**DOMINION NUCLEAR CONNECTICUT, INC.**  
**MILLSTONE POWER STATION UNIT 3**  
**RESPONSE TO REQUEST FOR ADDITIONAL INFORMATION REGARDING**  
**STRETCH POWER UPRATE LICENSE AMENDMENT REQUEST**  
**REVISED RESPONSE TO QUESTIONS EEEB-07-0052, EEEB-07-0054 AND**  
**EEEB-07-0055**

**Stretch Power Uprate License Amendment Request**  
**Response To Request For Additional Information**  
**Revised Response To Questions EEEB-07-0052, EEEB-07-0054**  
**And EEEB-07-0055**

**NRC Question EEEB-07-0052 Follow-Up (EEEB-08-0108)**

Figure 1: Pre- and Post-SPU Environmental Temperature Profiles

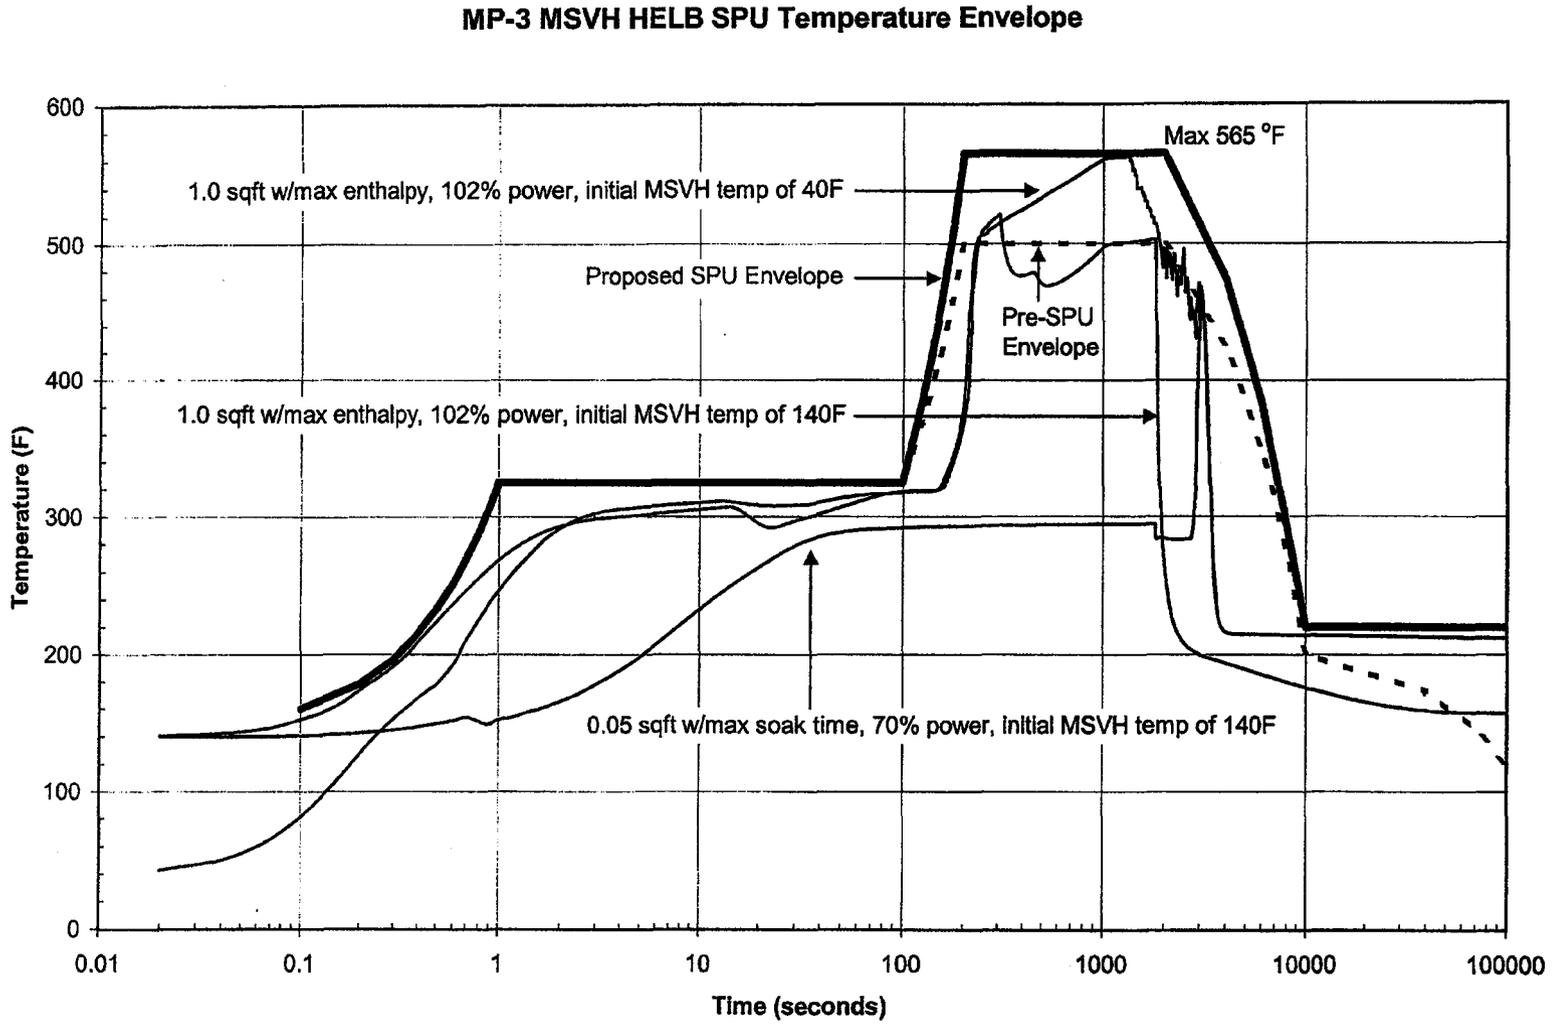
In the March 25, 2008, letter, the licensee states that the analysis for the Main Steam Valve Building (MSVB) following a main steam line break (MSLB) is performed for the duration of the component's mission time. Specify the mission time and function for each of the affected components in the MSVB. Describe the effects of the increased temperature and pressure on the affected components. In addition, explain, in detail, the assumptions and methodology used to evaluate the components. Provide a comparison of the pre-stretch power uprate (SPU) and SPU environmental temperature and pressure profile. Also, provide the detailed environmental qualification (EQ) evaluations and calculations for the ASCO solenoid valves, NAMCo limit switches, Rosemount pressure transmitters, Limatorque motor-operated valves and solenoids associated with Sulzer main steam isolation valves (MSIVs) and ITT actuators.

Provide the worst-case breaks and their impact on the EQ components for the MSVB EQ analysis.

A comparison of the enveloping pre- and post-SPU environmental temperature profiles is provided in Figure 1. The current EQ pressure profile envelopes post-SPU pressure profiles for all cases analyzed. Therefore there is no change to the EQ pressure profile. The enveloping EQ pressure profile is shown in Figure 2.

Figure 3: Pre-SPU Temperature Profiles for ASCO Solenoid Valves

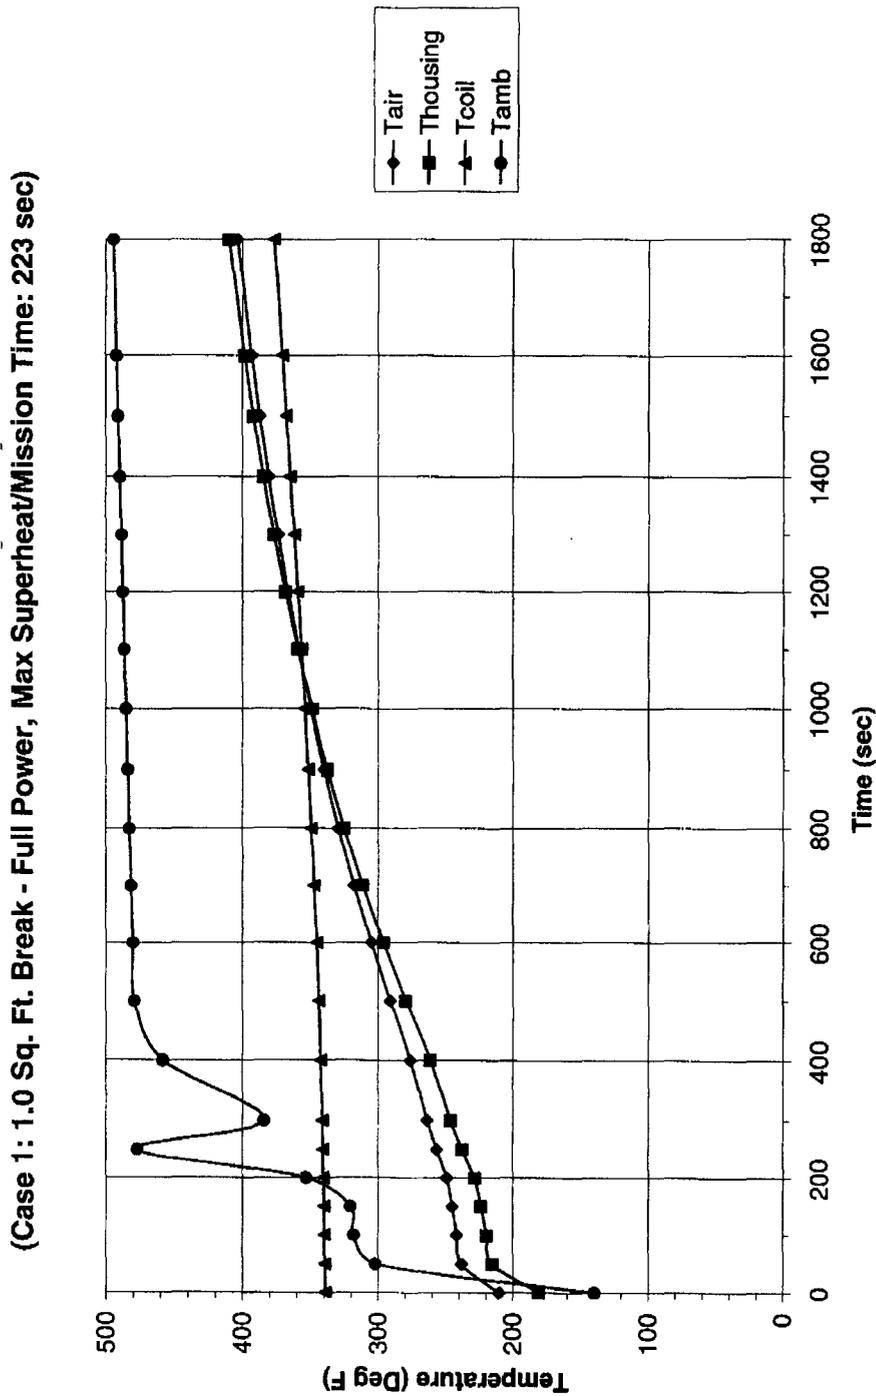
In the March 25, 2008, letter, the licensee states that the outside temperature (i.e. component casing temperature) of the equipment, instead of the internal temperature of the equipment, was conservatively compared with the component qualification temperature. Provide a basis for why the outside temperature is conservative for the affected EQ components.

Pre-SPU ASCO solenoid valve thermal lag analysis used a bounding environment temperature profile (i.e., 1.0 ft<sup>2</sup> break size, 102% NSSS power level, maximum enthalpy) and a maximum mission time of 1800 seconds. This maximum mission time bounds the MSI times for all break sizes analyzed. The analysis also assumes that the valves are energized to account for coil heat generation. The peak temperatures were determined for the solenoid coil, air gap and coil housing. The maximum post-SPU coil temperature is calculated by conservatively adding the temperature difference between the bounding pre- and post-SPU environment temperature profiles to the calculated peak pre-SPU coil temperature (See note on Figure 3). The peak temperature for pre-SPU environment temperature profile for solenoid valve qualification is 494.2°F (See Figure 3, curve labeled Tamb). The peak temperature identified in the post-SPU environment temperature profile for solenoid qualification is 562.2°F (See Figure 1, curve labeled 1.0 sqft w/max enthalpy, 102%, initial MSVB temperature of 140°F). The pre-SPU solenoid coil temperature at the maximum mission time (1800 seconds) is 377°F (See Figure 3, curve labeled Tcoil). The post-SPU peak coil temperature as identified in the note on Figure 3 is 445°F and remains below the 450°F ASCO solenoid valve qualification temperature.

Note: *post-SPU peak coil temperature = pre-SPU peak coil temperature + temperature difference between bounding pre- and post-SPU environmental profiles*

$$= 377^{\circ}\text{F} + (562.2^{\circ}\text{F} - 494.2^{\circ}\text{F}) = 377^{\circ}\text{F} + 68^{\circ}\text{F} = 445^{\circ}\text{F}$$

Figure 6: Post-SPU Limitorque Motor Temperature Profiles (with insulation)

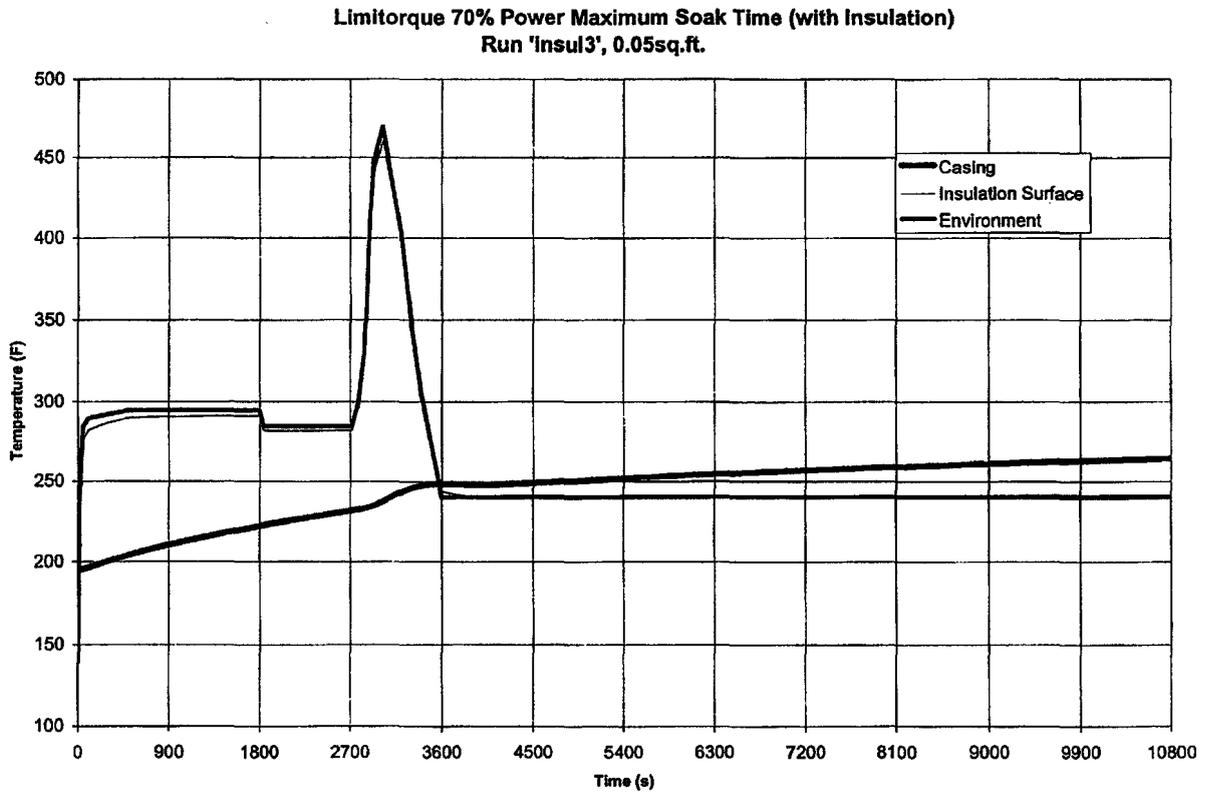
During the March 31, 2008, teleconference, the licensee stated that due to the temperature increase in the MSVB, a design change (enclosing the Limitorque motors with insulation) will be required to maintain the qualification of the motors. Describe the design change in detail and provide a detailed evaluation justifying how this new design, (enclosing the motors with insulation), does not impact the original qualification configuration of the Limitorque motors. In addition, provide a schedule for implementing the aforementioned design change.

Do the motor-operated valves installed in the MSVB use magnesium rotors? If yes, then evaluate the impact of high temperatures on the motors due to the SPU to ensure that these motors do not experience the failure mechanism identified in Information Notice 2006-26 and industry operating experience.

The peak MSVB environmental temperatures for all eight cases occur well within 3,600 seconds after break initiation. Therefore, the analysis was run for a period of 10,800 seconds (3 hours). Although the environment temperature drops rapidly after one hour, the analysis assumed a 240.5°F temperature for the remaining portion of the transient. In addition to the external heat flux from the harsh environment to the motor casing, the analysis assumed conductive heat flux from the valve to the motor casing. Therefore comparison of the higher casing temperature to the qualification temperature is conservative. The insulated motor casing temperature at 3 hours is 265°F, which is less than the 315°F motor qualification temperature. Post-SPU temperature profiles of the ambient and the motor casing are provided in Figure 6.

As part of SPU project implementation, a design change will be performed to insulate the 3MSS\*MOV18A, B, C and D operator motors prior to exceeding 3411 MWt. The subject motors are totally enclosed, non ventilated motors manufactured by Reliance and do not use magnesium rotors. They are qualified for 100% relative humidity. The design change proposes to install 1.5 inch thick

flexible blanket type insulation covering only the motor. Enclosing the motors with insulation is expected to increase the motor temperature during normal operation and thus, any impact that would reduce the motor service life will be evaluated. The design change process will evaluate the proposed modification to ensure that the installed condition will maintain the original motor qualification (i.e., test condition is applicable to the installed condition). Casing temperatures will be monitored pre- and post-modification, and any impact on the qualified service life will be incorporated into the EQ program for these motors. As part of the design change, plant procedures will be updated such that the motors will be inspected more frequently and replaced when necessary.
